Georgetown Charter Township

Planning Commission Meeting Agenda

- 7.I. (PUD1901-02) Sheldon Crossing Phase 2 Final Development Plan, L&V Development Co., 3373 Busch Dr., Is Requesting Final Development Plan Approval For Phase 2, On A Parcel Of Land Described As P.P. # 70-14-21-300-132, Located At 3045 Port Sheldon St., Georgetown Township, Ottawa County, Michigan.

REQUEST

Page 35

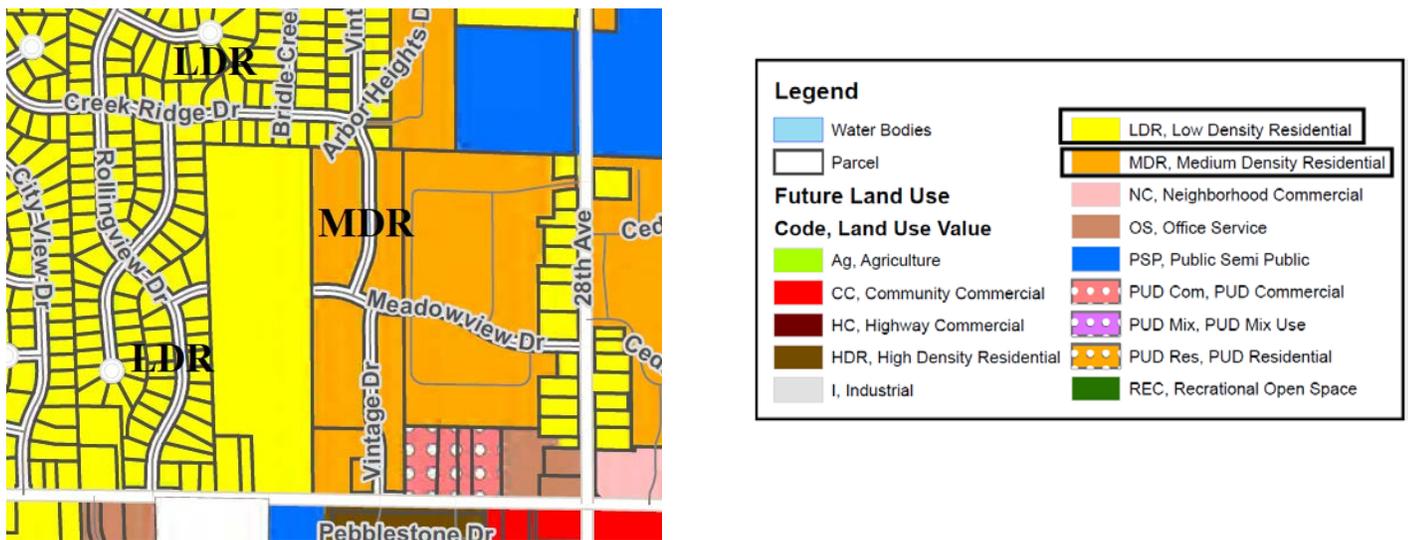
The proposal appears to be consistent with the text and Future Land Use Map in regard to the uses and the density. The Future Land Use Map shows the area as LDR. The plan proposes 3.3 units per acre which is close to being consistent with an overall density of 3 units per acre which meets the intention of page 36 in the Master Plan. Further, page 35 of the Master Plan states the following and the property to the east is designated Medium Density Residential.

It is noted that lines separating land use categories are NOT to be considered to be defined lines and the lines are not necessarily parcel specific.

Zoning Map

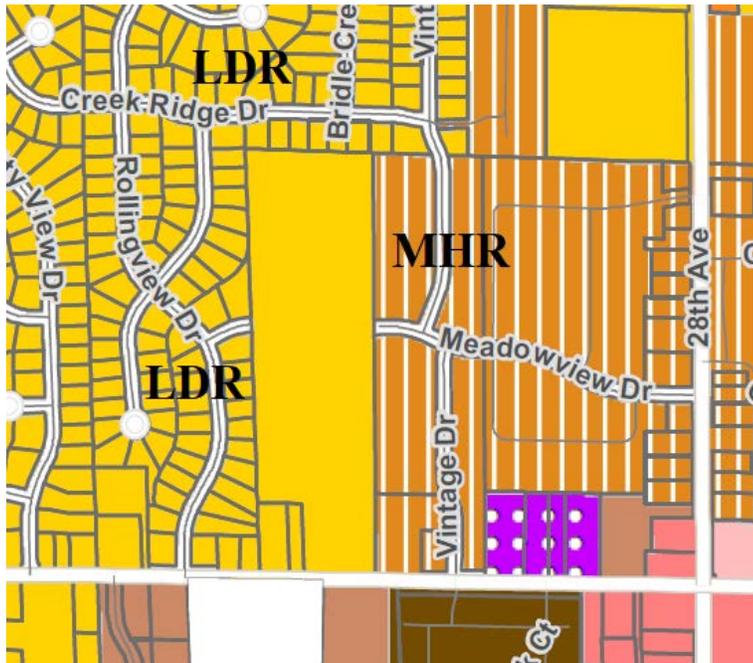
The following is the Future Land Use Map related to the proposed PUD development.

SITE DEVELOPMENT PLAN - SHELDON CROSSING - PHASE 2
 FOR: L & V DEVELOPMENT CO.
 ATTN: LARRY KERKSTRA
 3373 BUSCH DRIVE
 GRANDVILLE, MI 49418

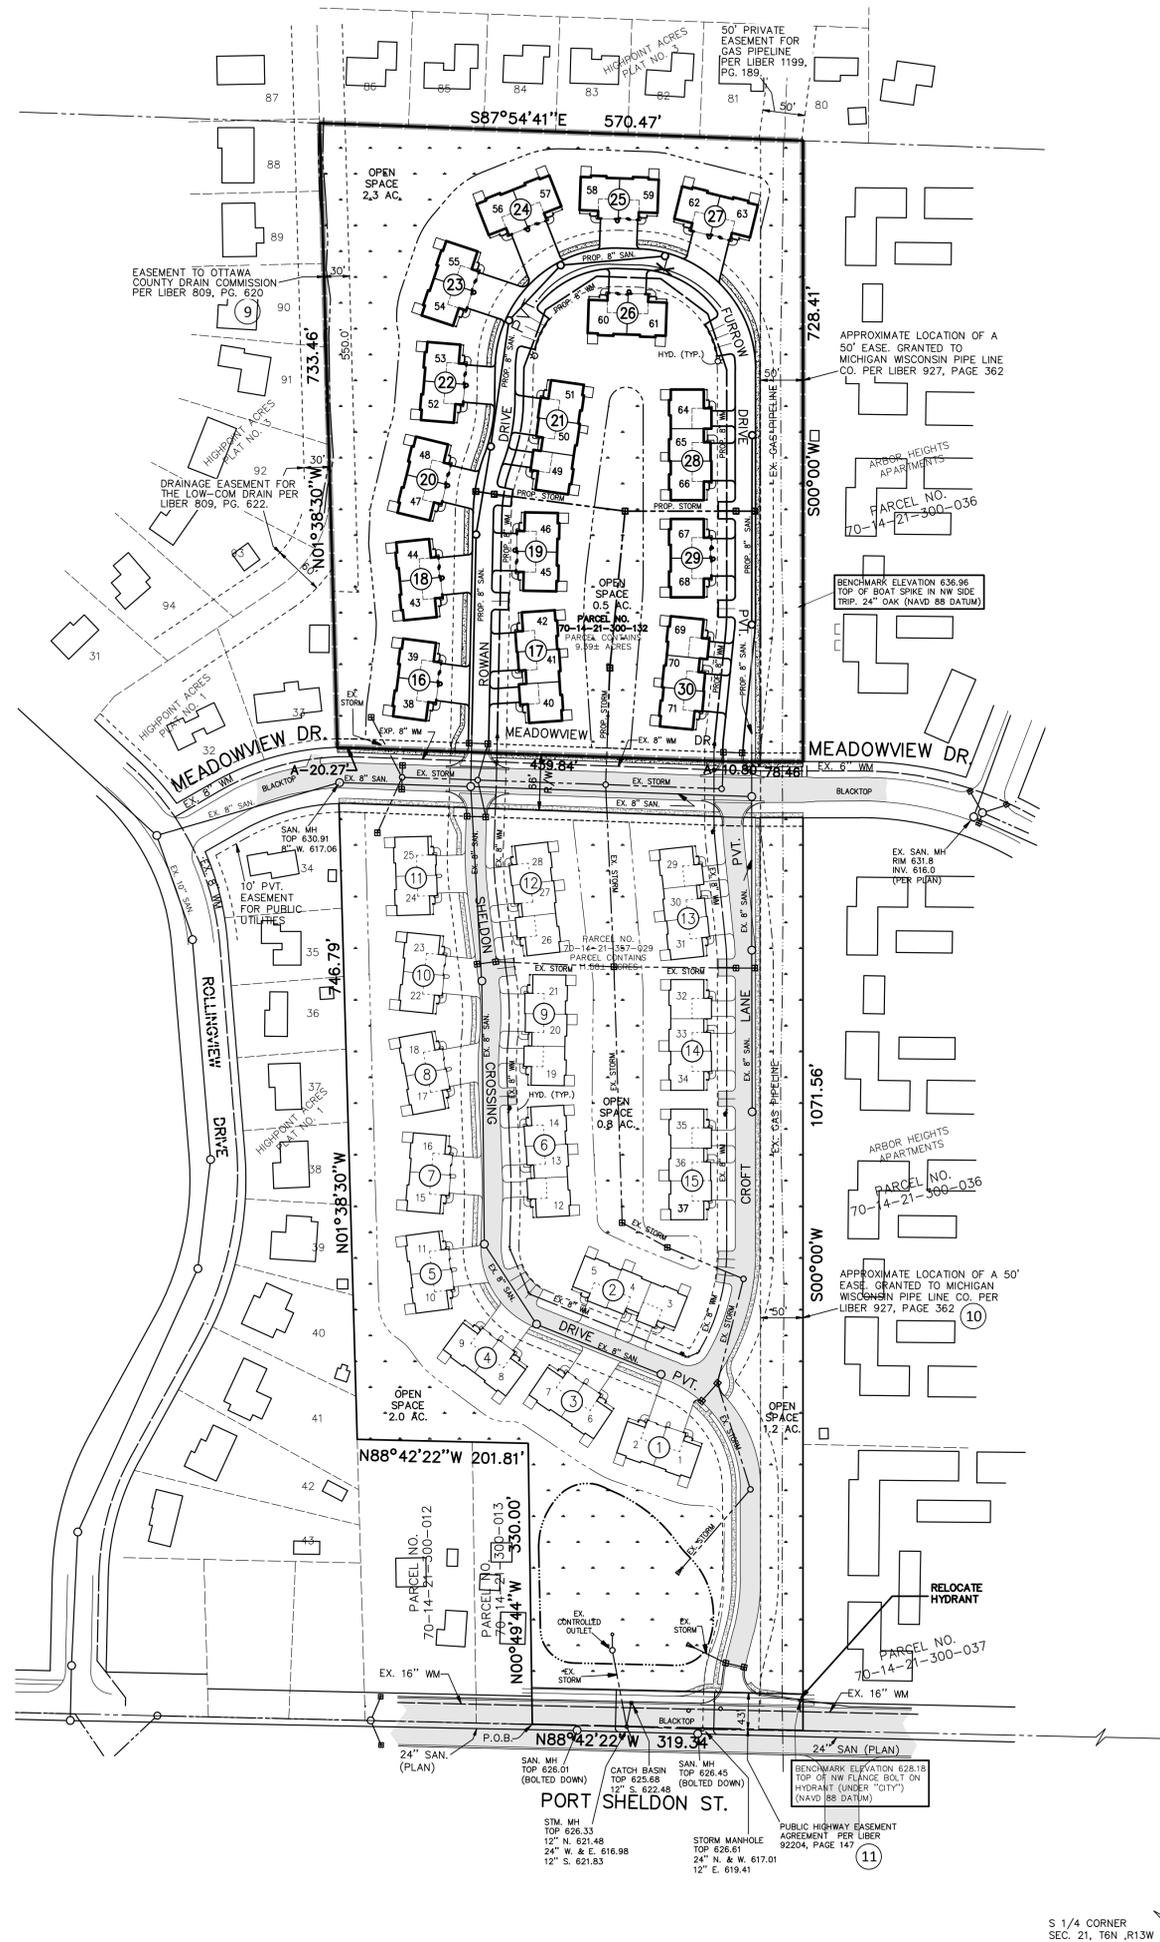
1. **Attached dwellings.** In the current LDR zoning, single family houses are allowed and attached dwelling units are not allowed. They are allowed in the higher density residential districts only (unless in a PUD). The plan proposes 30 condominium buildings with a total of 71 total units. Of the 21.5 acres, 7 acres is proposed to be open space, which exceeds the 20% minimum. For the 21.5 acres used in the density computation, with 3 units allowed per acre as per the Master Plan, 64 total units are allowed and the plan proposes 71. That is 7 more units than allowed per the Master Plan density. However, the narrative notes this area is a transition from the LDR to the west and the medium/high density residential area. Note also that the Master Plan is not intended to be parcel specific, but rather the lines should be considered to be wider. The Planning Commission will have to determine if the 11% additional units meet the intention of the Master Plan and if they should be allowed.

2. **Distance between buildings.** Footnote (j), which is applicable to the MHR district in Chapter 24, requires a minimum of 25 feet between contiguous buildings. The plan proposes a minimum of 18 feet, which is 7 less than the regulatory 25 feet.

3. **Setbacks.** With the current LDR zoning, a minimum front yard setback of 40 feet is required and is to be measured from a point 60 feet from the centerline of Port Sheldon. This is met along Port Sheldon. The plan proposes a minimum of a 35 foot front yard setback north and south of Meadowview Dr. This is 5 feet less than the 40 feet required for the conventional LDR zoning. Side yards are proposed to be a minimum of 50 feet which exceeds the 10 foot required in LDR. The rear along the northern property line is proposed to be 40 feet which meets the current LDR standard.

4. **Sign.** Sec. 25.2(L) defines a plat entry sign as a sign placed as a road entrance to a subdivision, mobile home park or multiple-family development. Since this is a multiple-family development, the plat entry sign is what would be allowed. Sec. 25.6(A)(5) allows plat entry signs as follows: two per road entrance each not exceeding a total area of 64 square feet in area nor 3 feet in height, and setback a minimum of at least 10 feet from 60 feet from the centerline of Port Sheldon (total of 70 feet from the centerline). Only one sign is proposed and is shown as 5.5 feet high (**a deviation of 2.5 feet from the maximum of 3 feet**) and to have 46.75 square feet in area (less than the maximum of 64 square feet allow). The sign is proposed to be located 58 feet from the centerline (**a deviation of 12 feet from the minimum of 70 feet from the centerline**).

Met. Interior sidewalks are proposed, as well as sidewalks on both sides of Meadowview Dr.

The plan states that 6.8 of the 21.5 acres are open space, which is about 32 of the property and exceeds the minimum amount required. The open space is passive with many sidewalks.

Enclosed attached garages are required for all dwelling and are required to be a minimum size of 200 square feet. A minimum of 1,000 square feet in area is required for each individual dwelling unit. The plan notes that the individual dwelling units will be a minimum of 1,150 square feet in area with a minimum of a 400 square foot attached garage.

Motion: To adopt the staff report as finding of fact and to approve the final development plan with the previously approved deviations, and with the following conditions:

1. **Each unit shall be a minimum of 1,150 square feet in area with a minimum of 400 square foot attached garage.**
2. **A Storm Water Drain Permit (written approval by the Drain Commissioner's office) shall be submitted to the Township prior to the submission of the first building permit application.**

3. **Utilities are to be coordinated with the DPW and Drain Commissioner's office.**
4. **As per Sec. 22.11, a recorded PUD agreement shall be submitted to the Township prior to the submission of the first building permit application, as noted on the plan.**

5. **Approved permits are required for all signs and all signs shall meet the details listed in the submittal documents or in the ordinance standards.**

6. **If not already installed, as per language noted on the plan, the developer is voluntarily providing the deceleration taper lane to be constructed as per Ottawa County Road Commission standards.**
